# PLAN COMMISSION

Wednesday, April 10, 2024 – 6:30 PM

- B. Review/Recommendation: Plan Commission review & recommendation on a Conditional Use Application submitted by Kunes Appleton Properties for a proposed addition to the existing heavy vehicle sales and rental principal building located at 2615 West American Drive, specifically described as Tax ID #006-0341-01.

- C. Review/Recommendation: Plan Commission review & recommendation on a Site Plan Application submitted by Kunes Appleton Properties for a proposed addition to the existing heavy vehicle sales and rental principal building located at 2615 West American Drive, specifically described as Tax ID #006-0341-01.

CIVIL SITE PLAN WEST

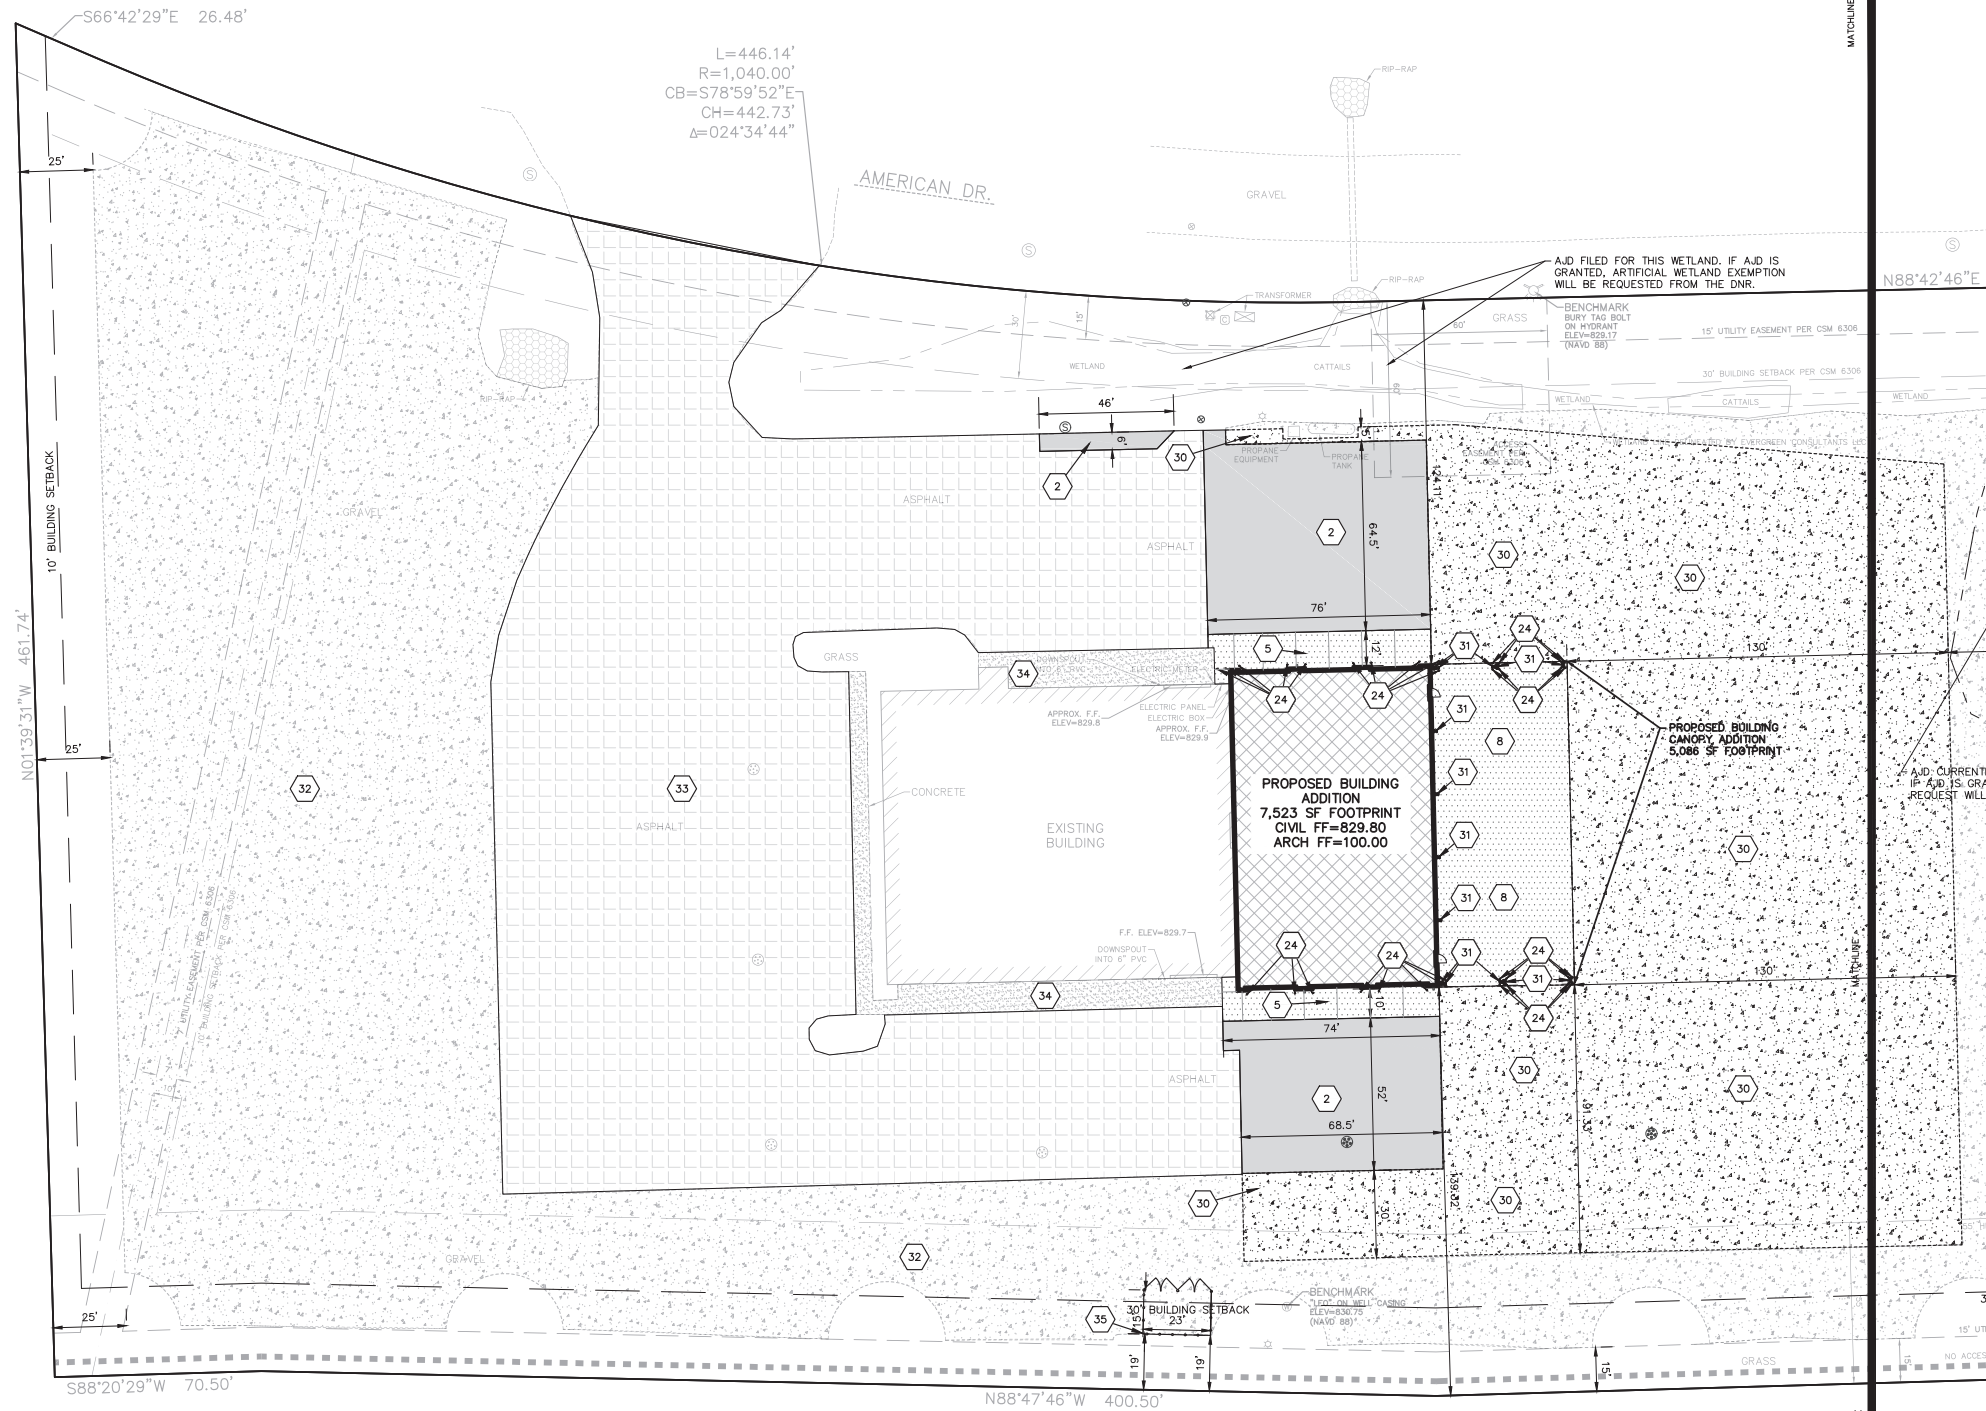
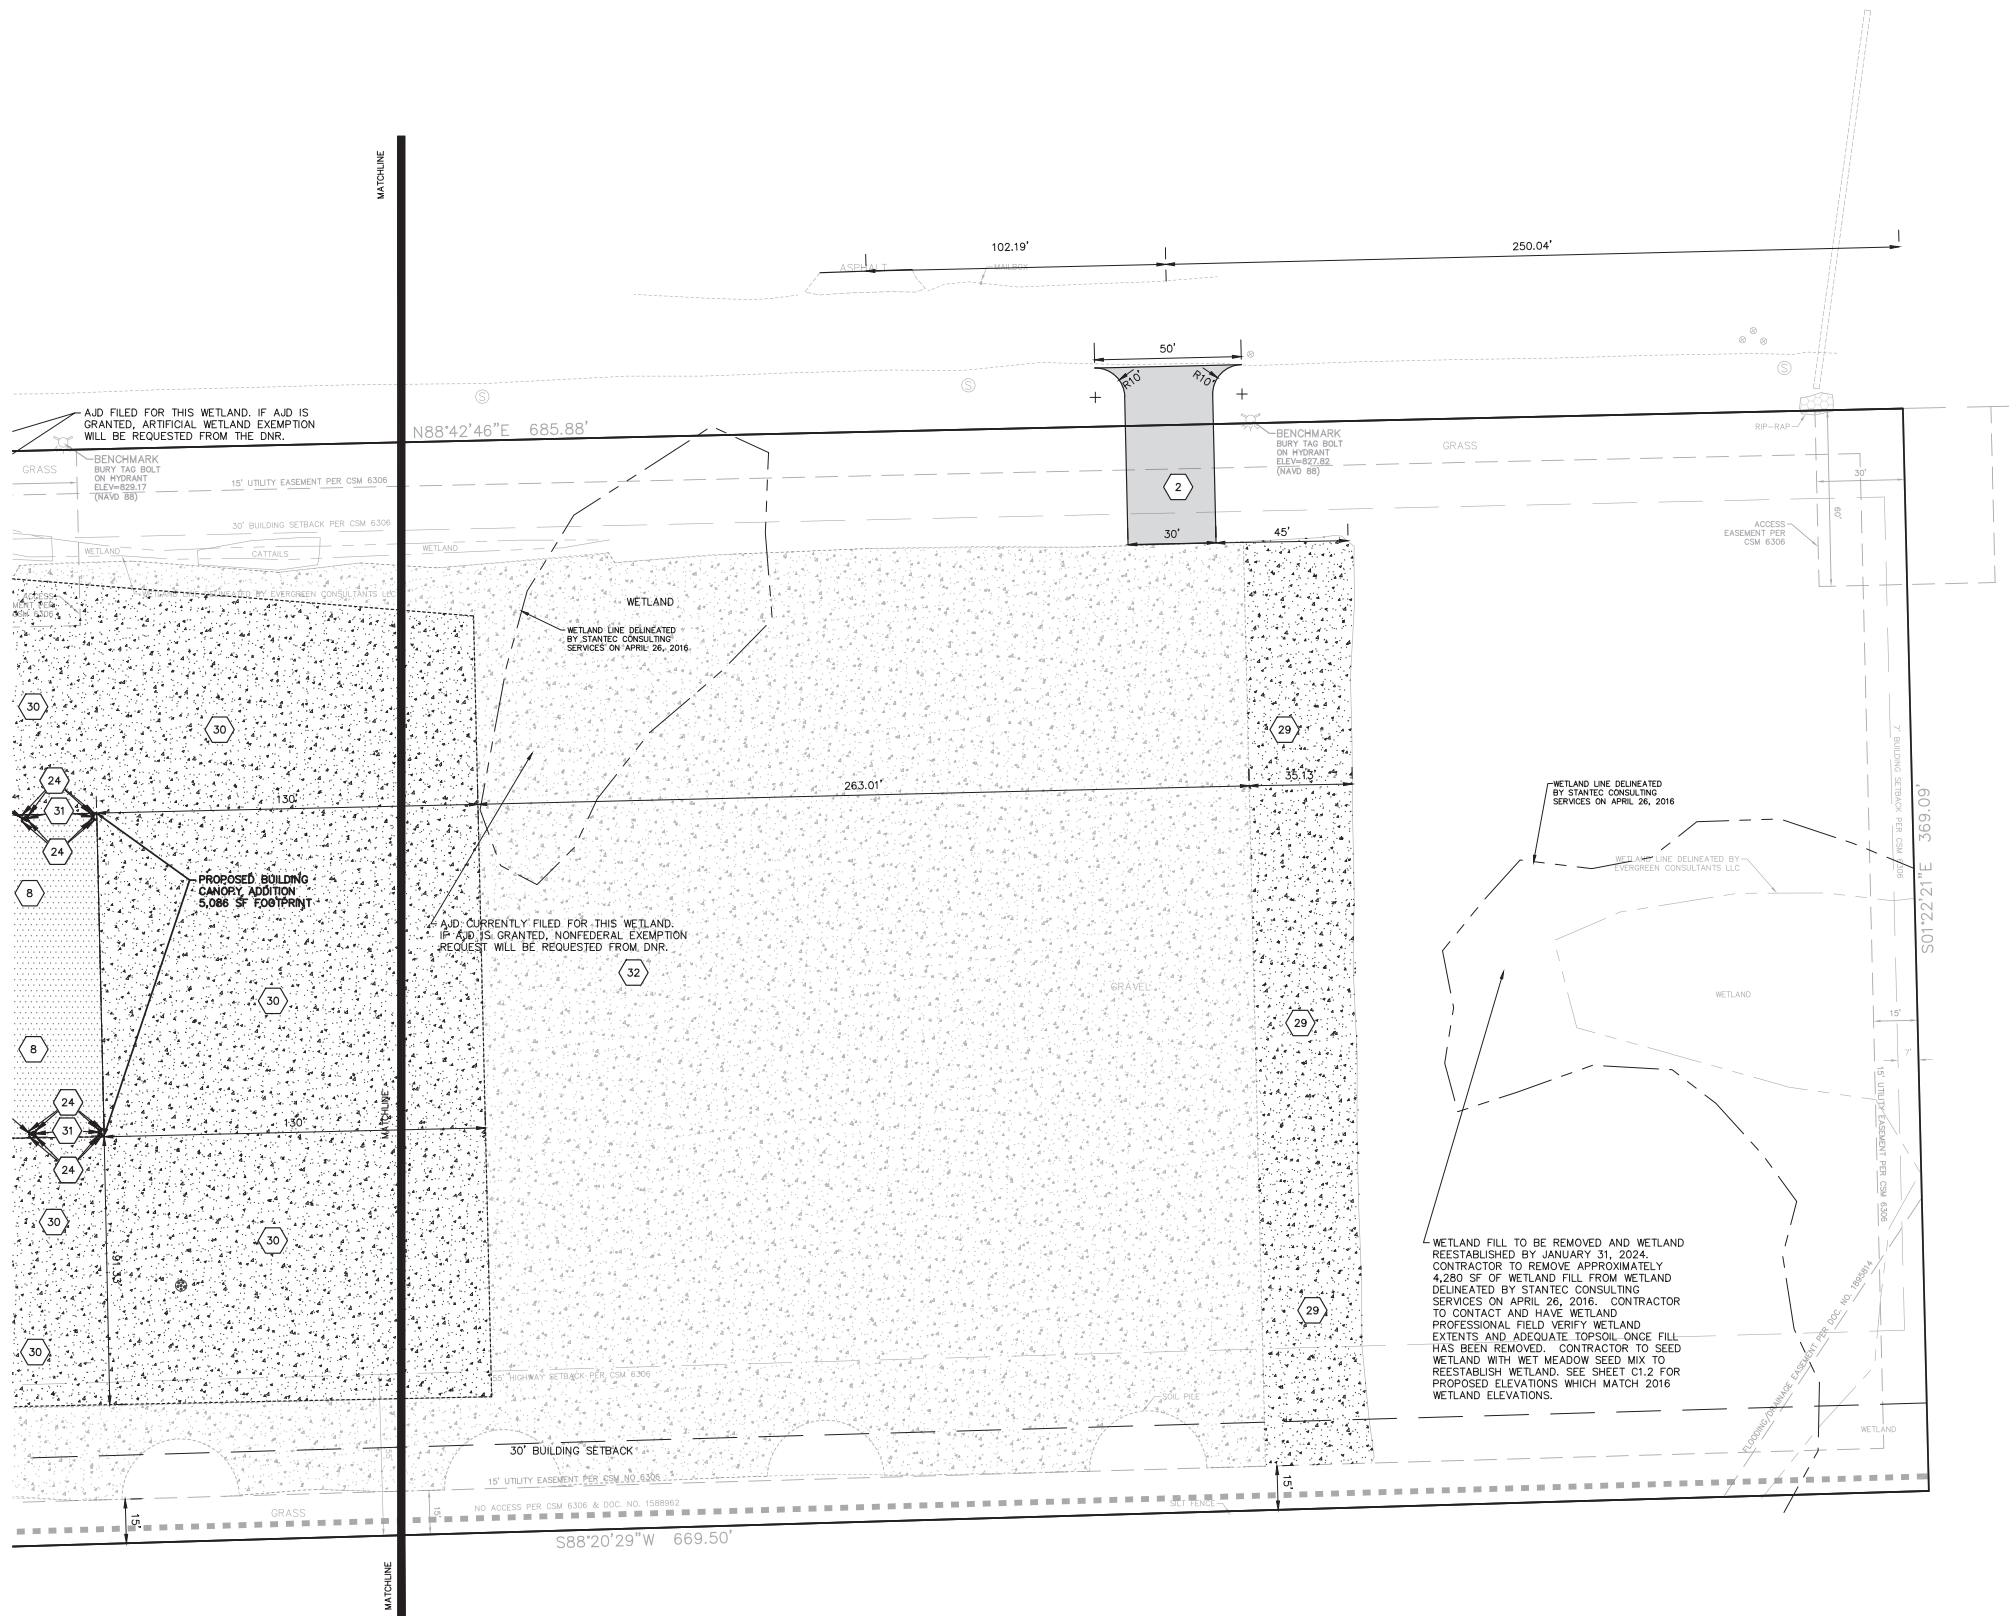
1. Proposed new driveway in eastern portion of property exceeds the 36 ft. maximum width requirement at the juncture with the street pavement.
  - Plan Commission will need to determine if compliance with the driveway width requirements of Attachment B will be required for the proposed driveway or if Plan Commission will recommend allowing the driveway as proposed.

1. Gravel outdoor camper display area does not comply with the 2017 Site Plan Approval and the 25 ft. outdoor display area setback requirement per Sec. 9.08-291.

- Staff recommends requiring the applicant to submit revised site plans identifying compliance with the 2017 Site Plan Approval and, for display areas installed beyond the 2017 approval, compliance with Sec. 9.08-291 prior to Conditional Use Permit and Site Plan approvals.

**Excel Response: 25' setback to west now provided in updated plans. 15' setback to south now provided in updated plans as well.**
2. Applicant did not provide Winnebago County and Wisconsin Department of Natural Resources (DNR) stormwater management and erosion control permits/approvals.
